Addendum No. 1

Architectural and MEP Design Construction Documents
Trauma Advance Practice Interior Renovations within
JPS Main Hospital Building on the First and Third Floor

**15-0717 Trauma Advance Practice Interior Renovations
First Floor of the Hospital Main Building**

**15-0718 Trauma Advance Practice Interior Renovations
Third Floor of the Hospital Main Building**

S1

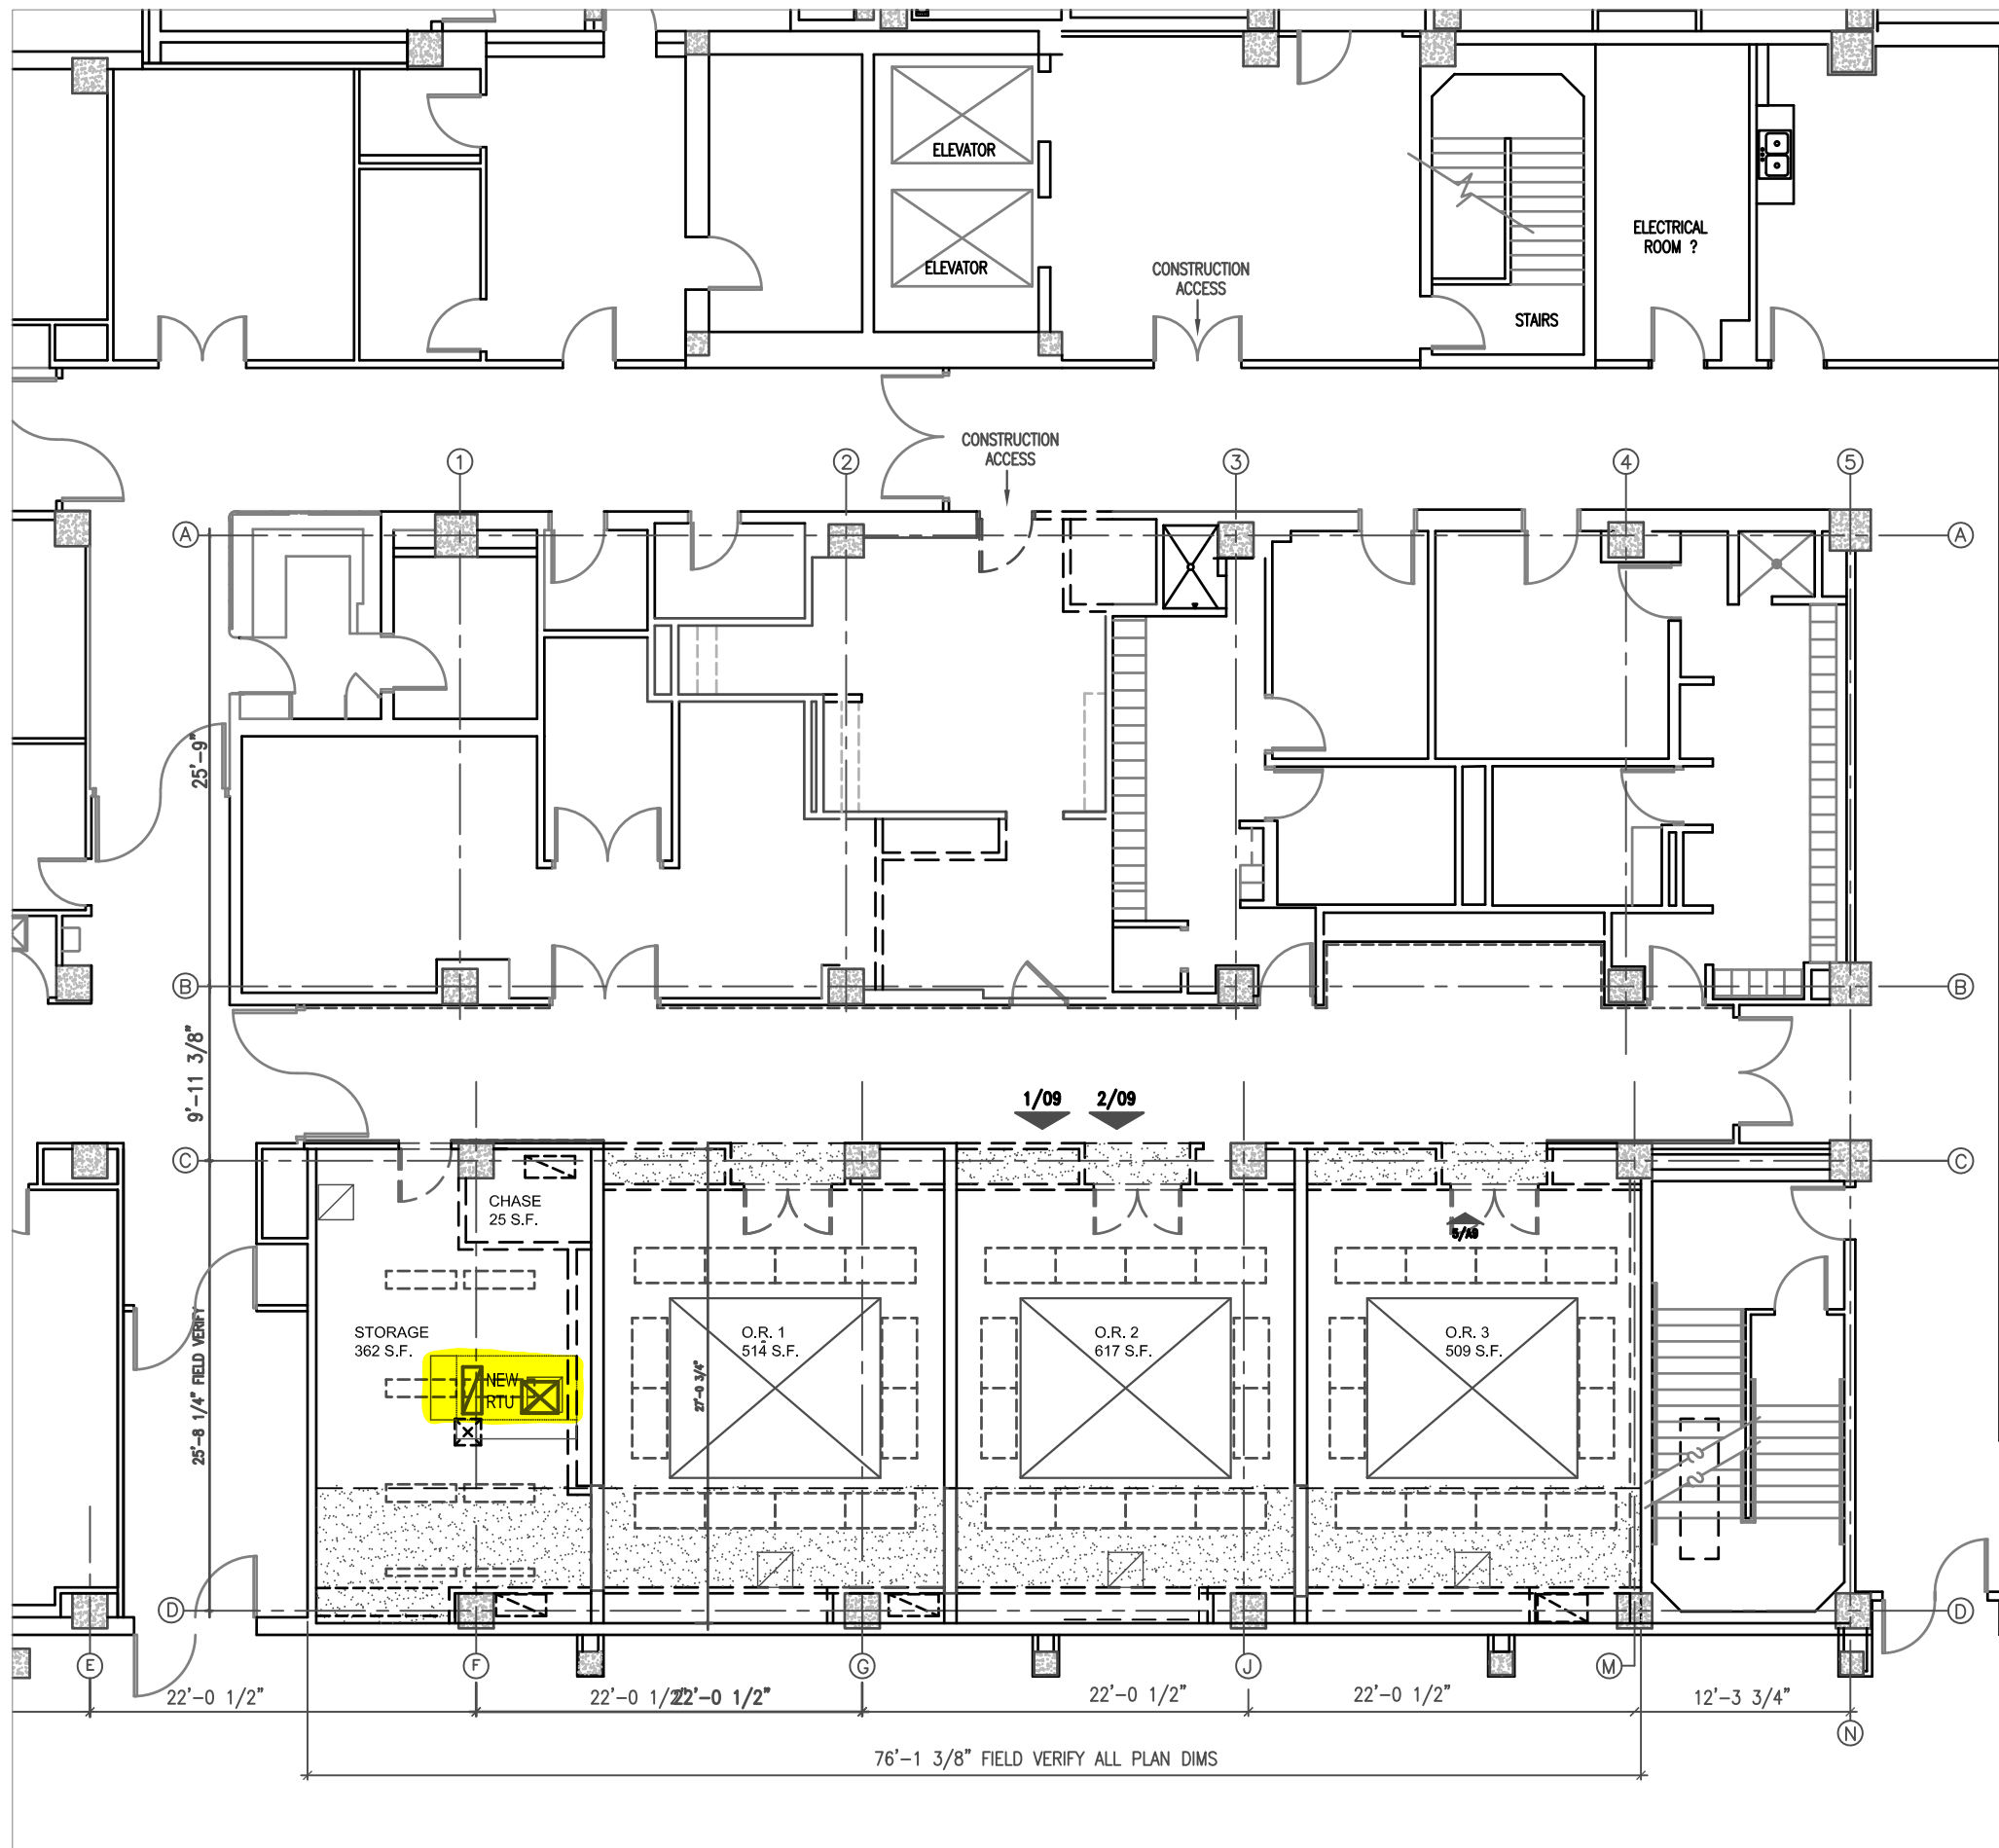
After review, it is our professional opinion that the roof framing is capable of safely supporting the proposed new mechanical roof top unit when located as indicated on the attached sketch. Please find the enclosed drawing, S1, specifying allowable locations for creating the roof penetrations.

PROVIDE PILOT HOLES FROM BELOW ROOF
PRIOR TO SAW CUTTING OPENING IN ORDER TO
ENSURE THAT THE JOIST STEMS ARE NOT CUT
